CASE #PL2020-201

Issues and Revisions:
DRC REVIEW 10-14-2020

100 HEALTH

SITE PLAN

1 SITE PLAN
A1 1"=30'-0"

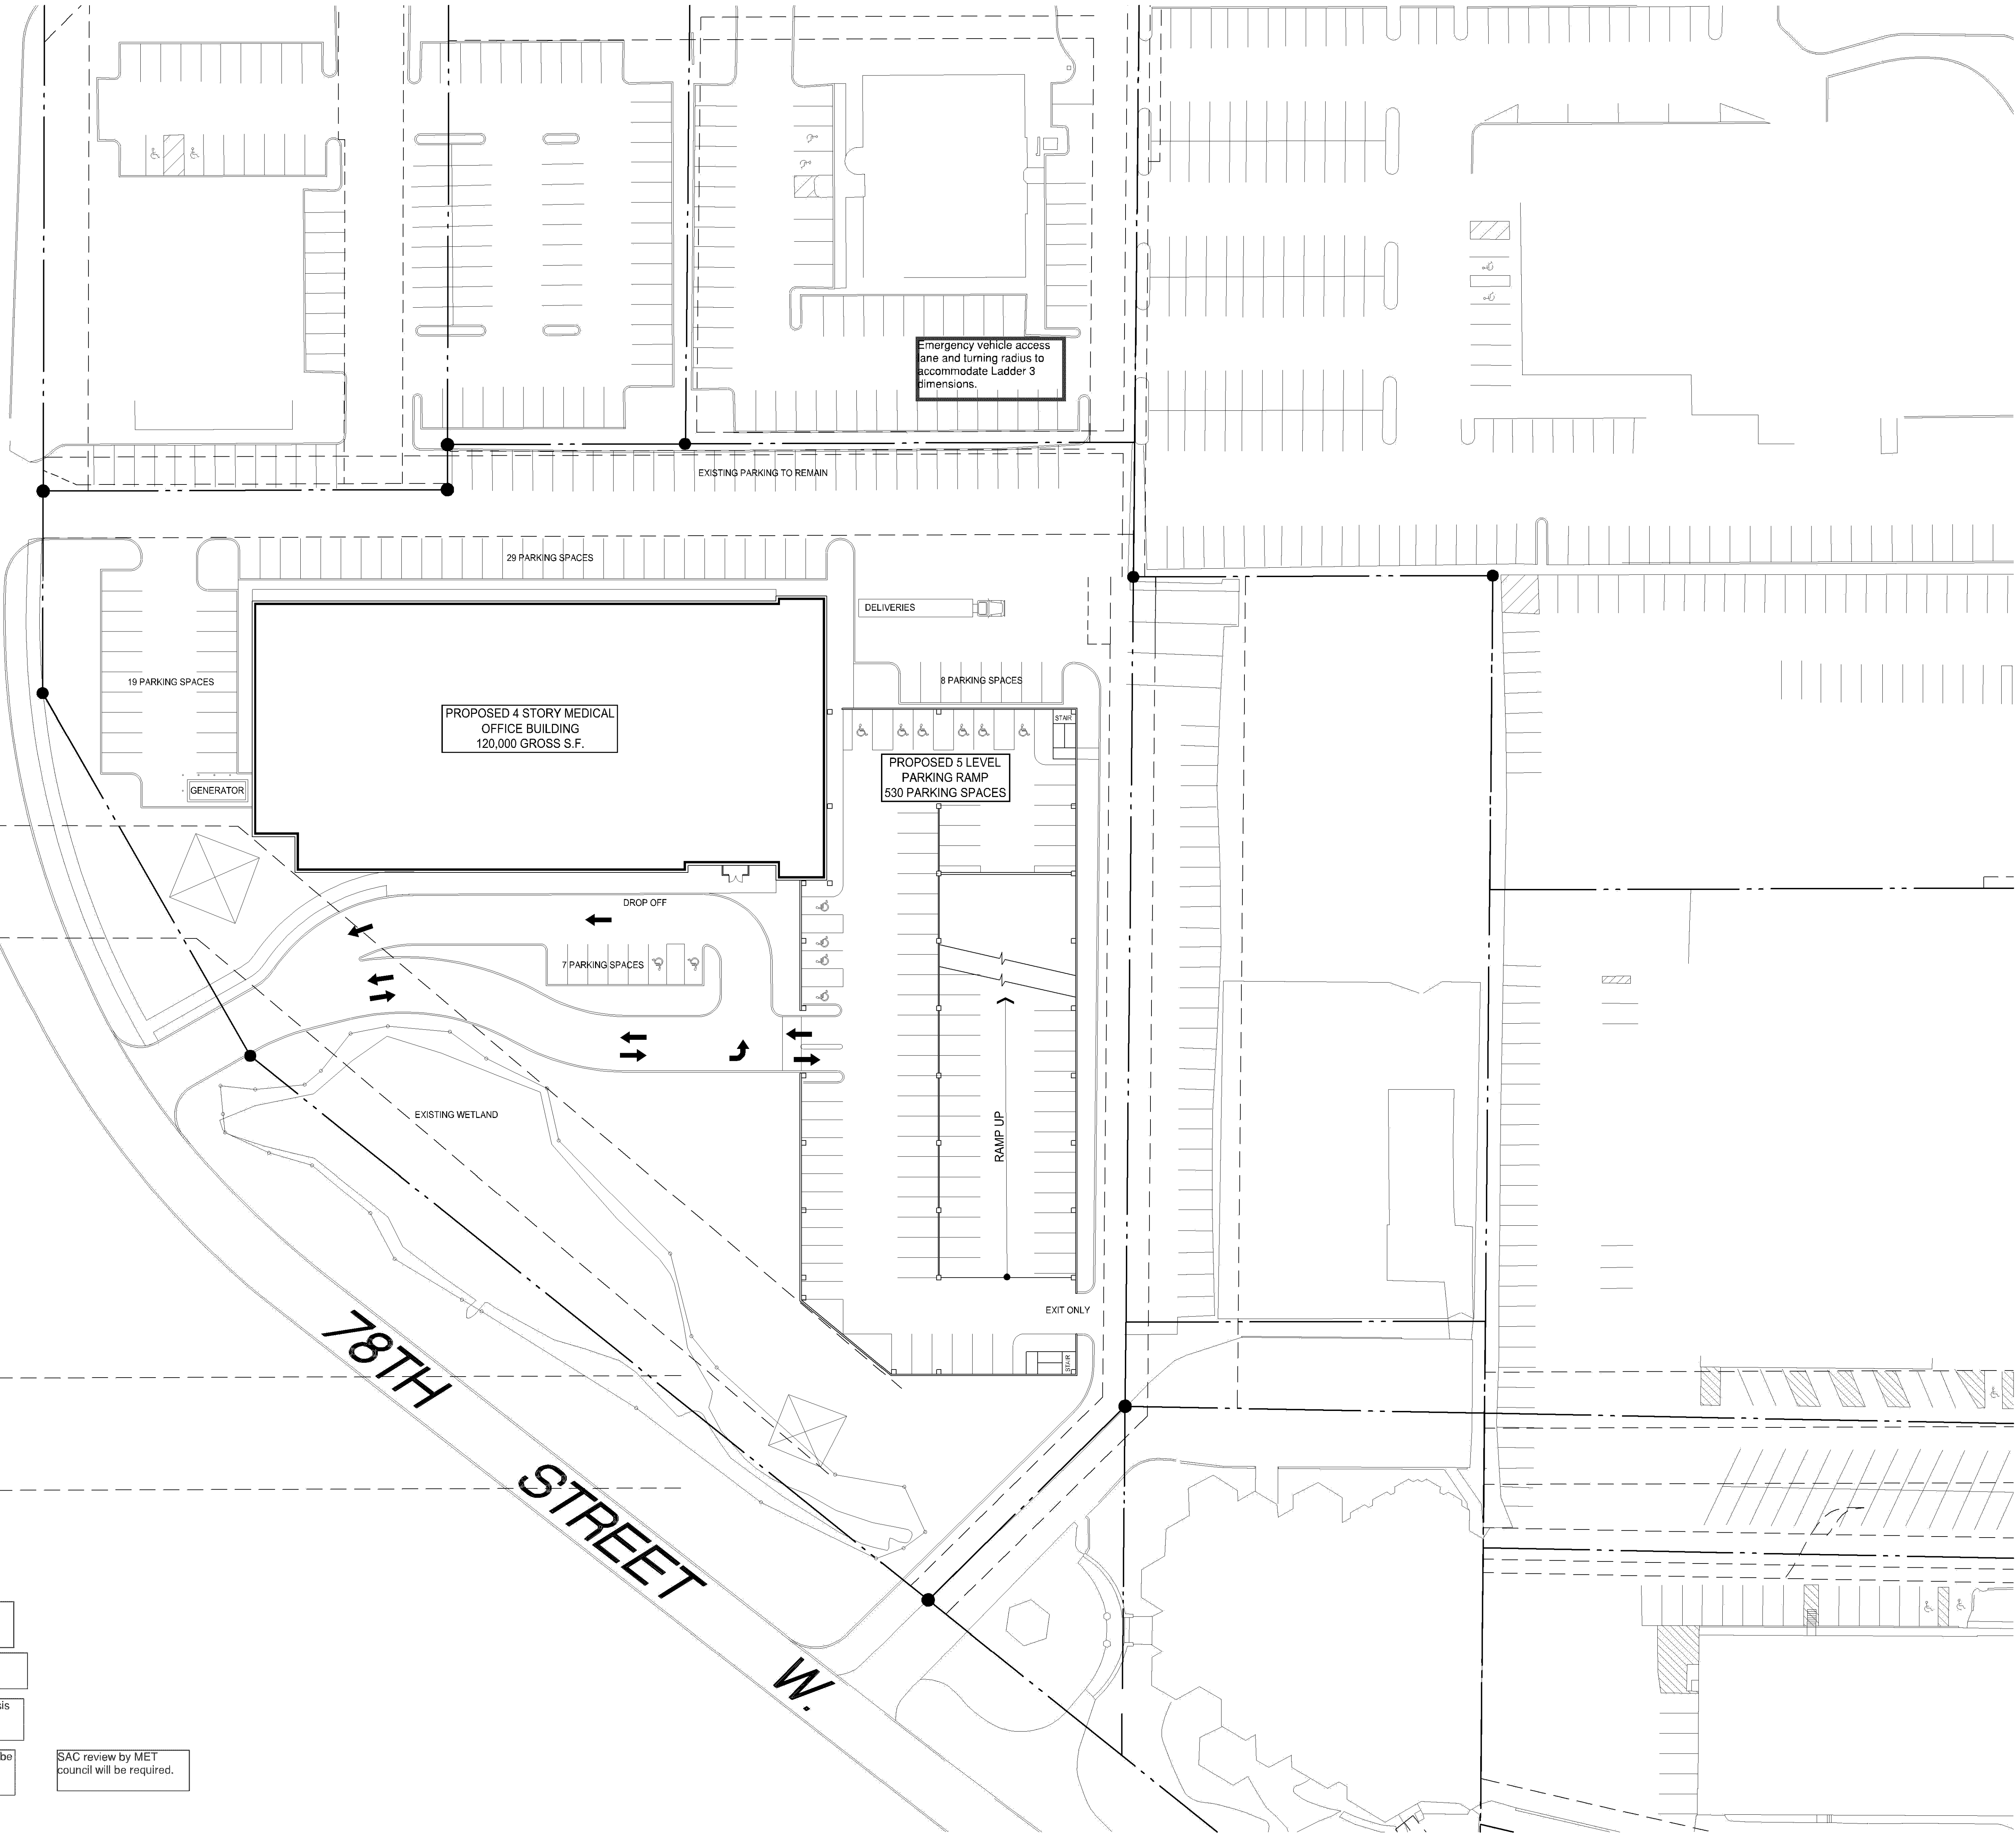
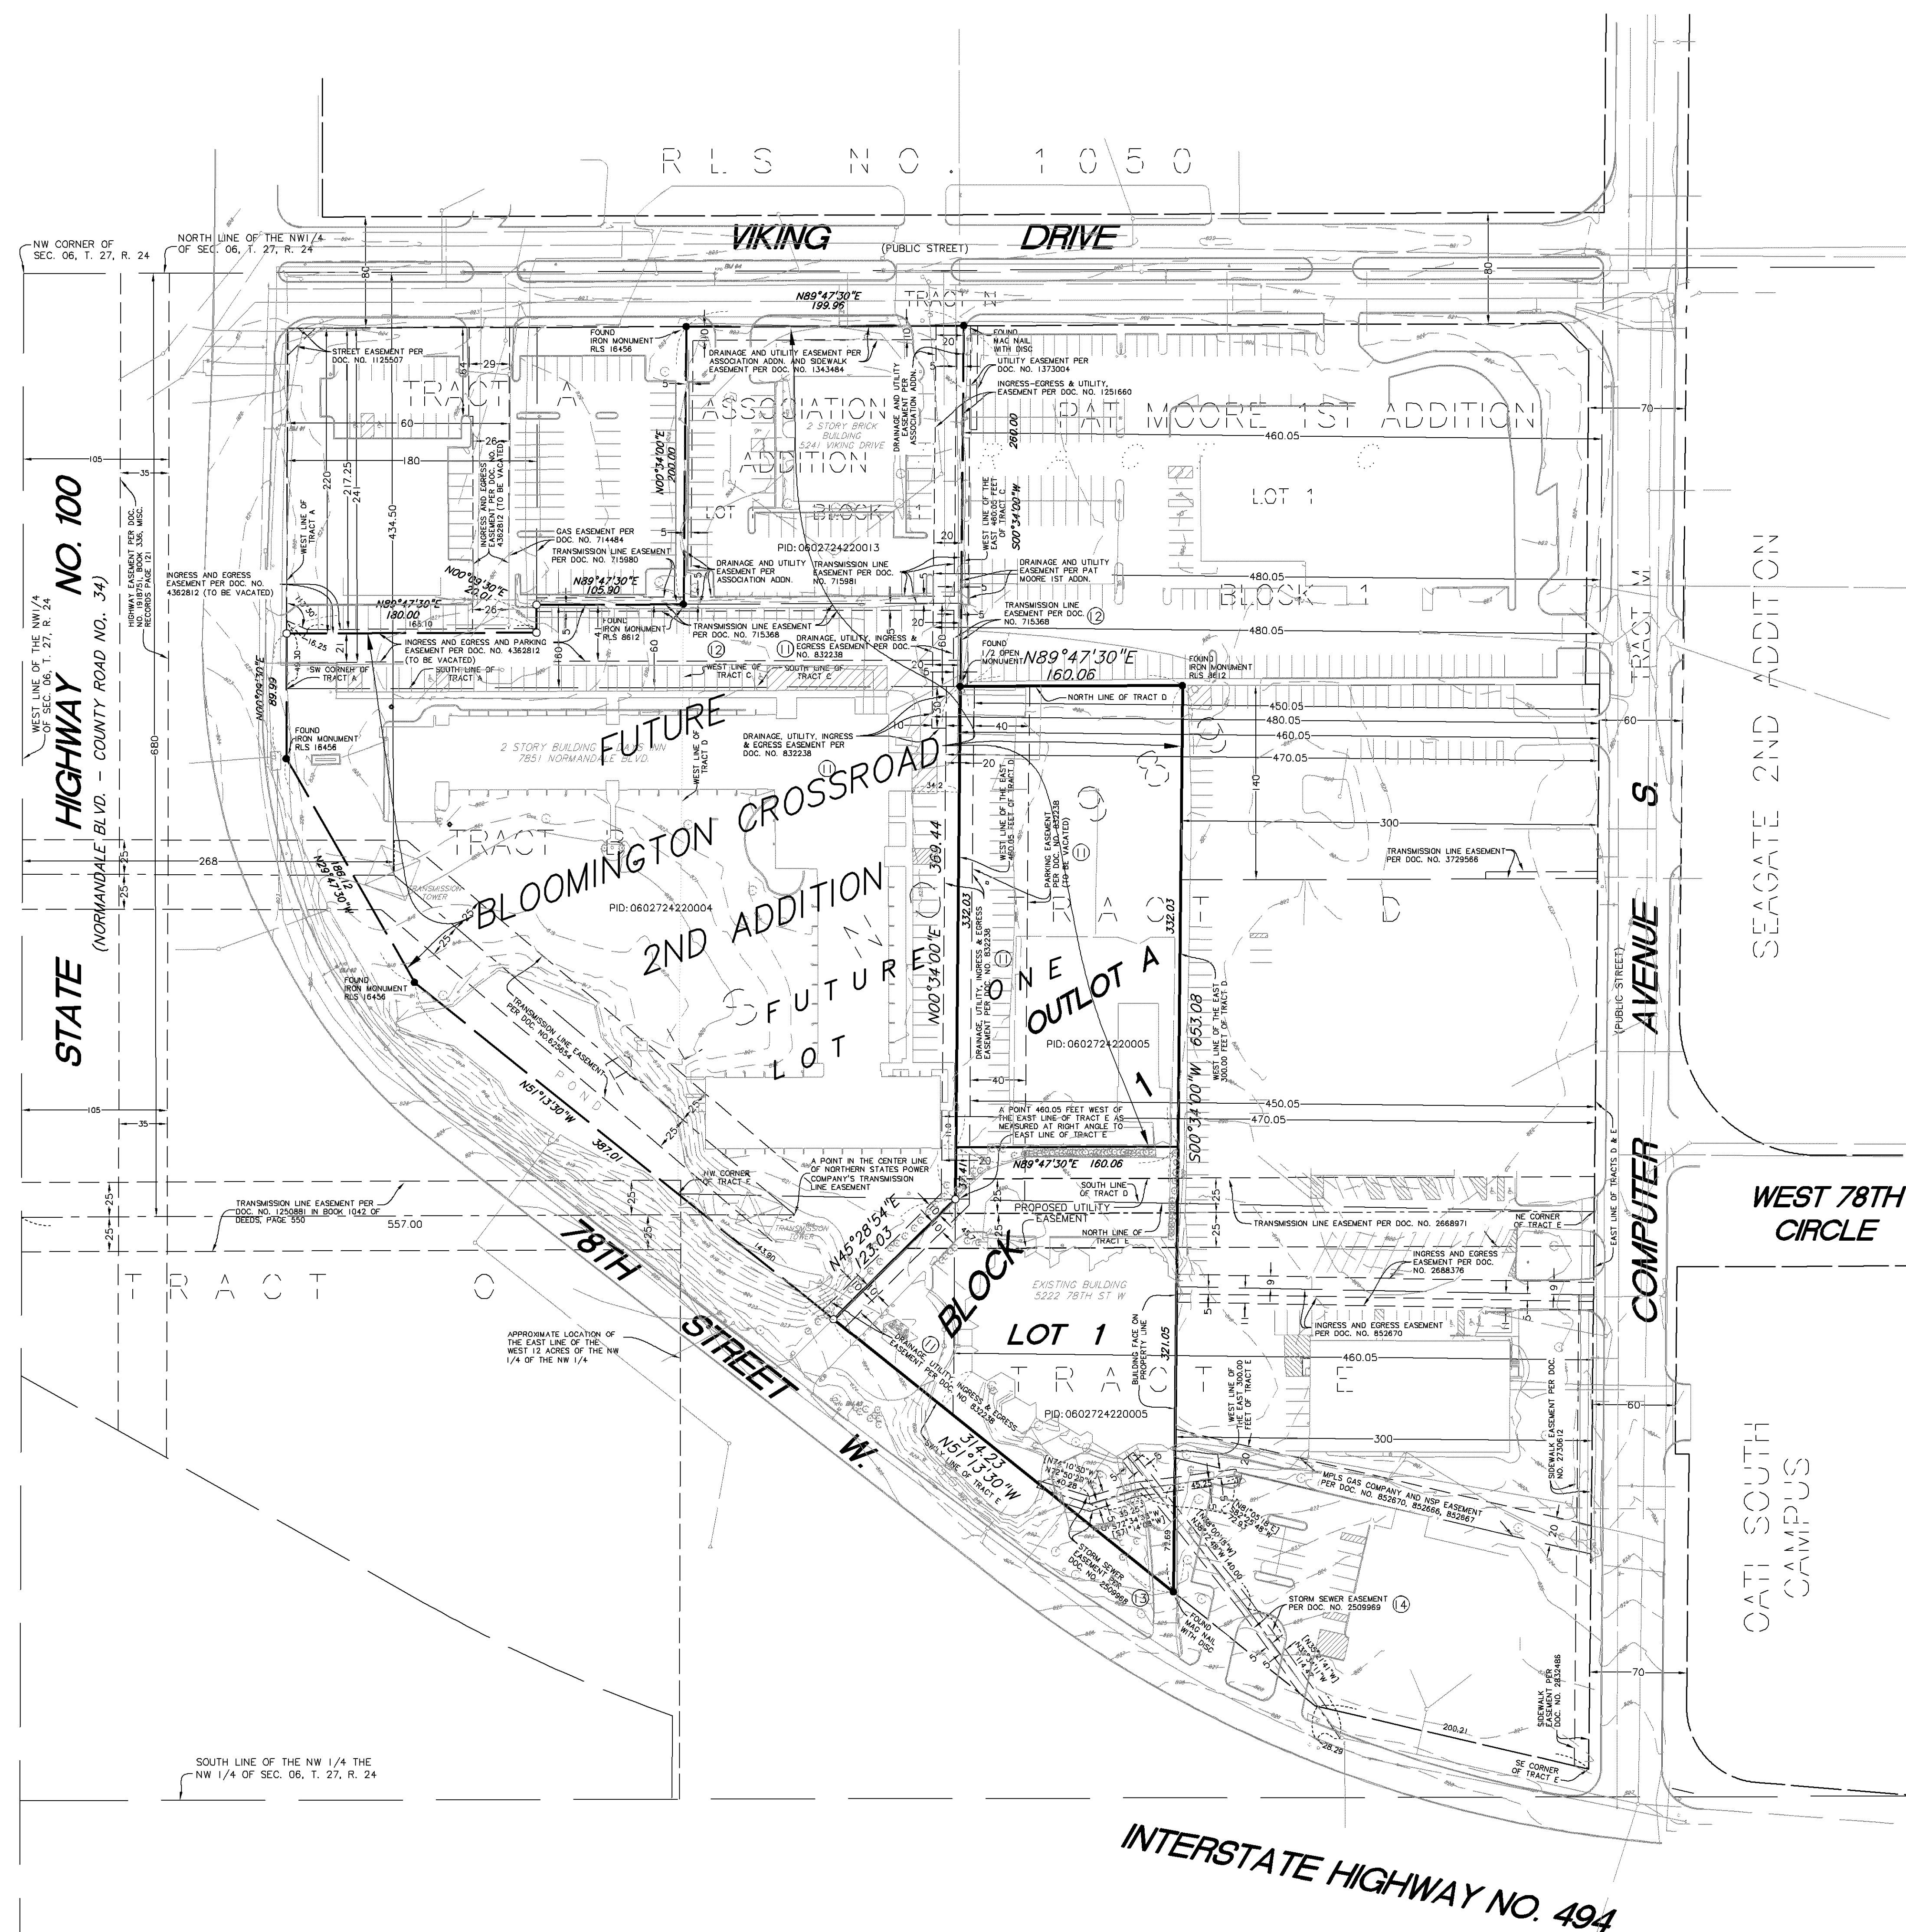
Building/property shall be adequately signed for emergency response.

Emergency responder radio coverage meeting the requirements of appendix L in the 2015 MSFC shall be provided throughout the property and within the structures.

Fire alarm and annunciator panels and Knox box locations to be determined by the Fire Prevention Division.

Hydrant coverage shall be provided within 50' of the FDC and within 150' of all portions of the structure.

If the parking ramps is partially or fully enclosed per the building code, sprinkler protection may be required. Standpipes will be required regardless.

Must meet 2020 MN State Building Code

Must meet 2020 MN Accessibility Code

Provide a code analysis with the plans.

Building plans must be signed by a MN licensed architect.

SAC review by MET council will be required.
